# Technical Bulletin

**40 12 02** June 27, 2012 **2014645** Supersedes T. B. V401001 dated September 24, 2010 to add additional CC model year applicability.

## Front Suspension, Knocking Noise

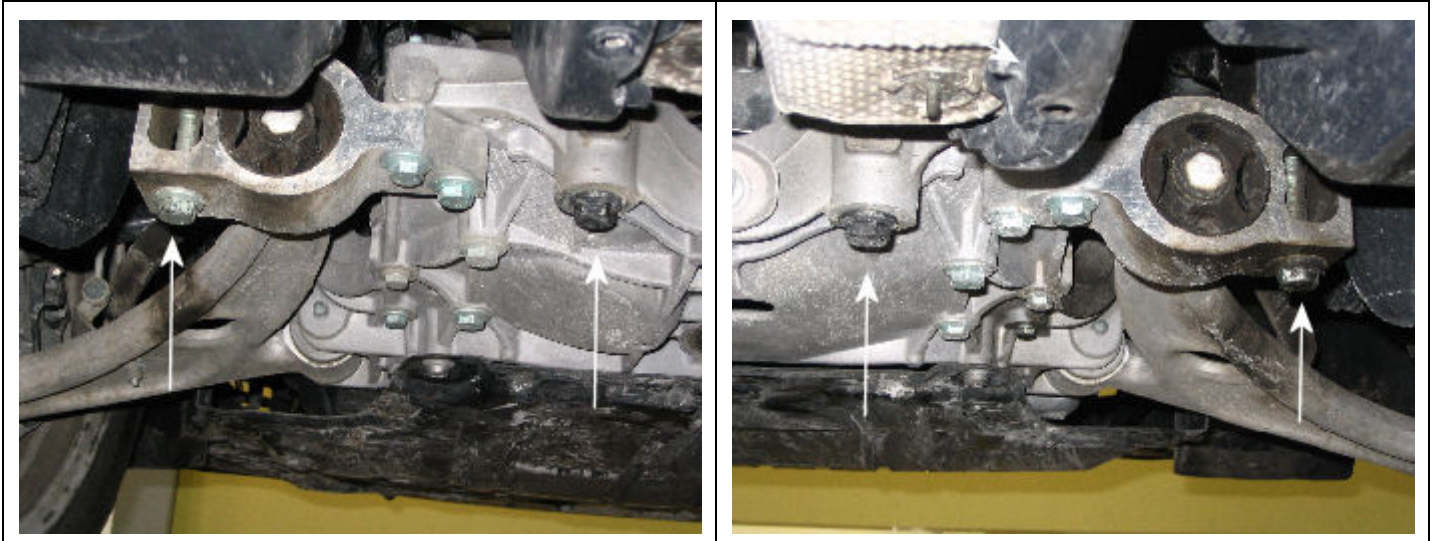
Knocking noise from vehicle front. Typically occurs only one time after each direction change (forward or backward, left or right).

The sub frame shifts slightly relative to the body due to wax residue in-between components. Maximum acceleration and braking in vehicles that are driven hard are contributors to the occurrence.

Install two specialty plates (washers) Part No.: 7M3499349A following the procedure below.

- Loosen by two turns, the four bolts towards the rear of the sub frame.
- Remove one inboard bolt.

- Insert washer Part No. 7M3499349A between sub frame and body, centered on the hole with tabs of washer pointing rear and down as shown.
- Insert a new bolt and hand tighten.
- Repeat the above procedure with second inboard bolt.
- Tighten all 4 bolts, in accordance to Repair Manual Group 40 Front suspension, driveshaft in ElsaWeb

Sub frame bolts **MUST** be replaced after every removal.
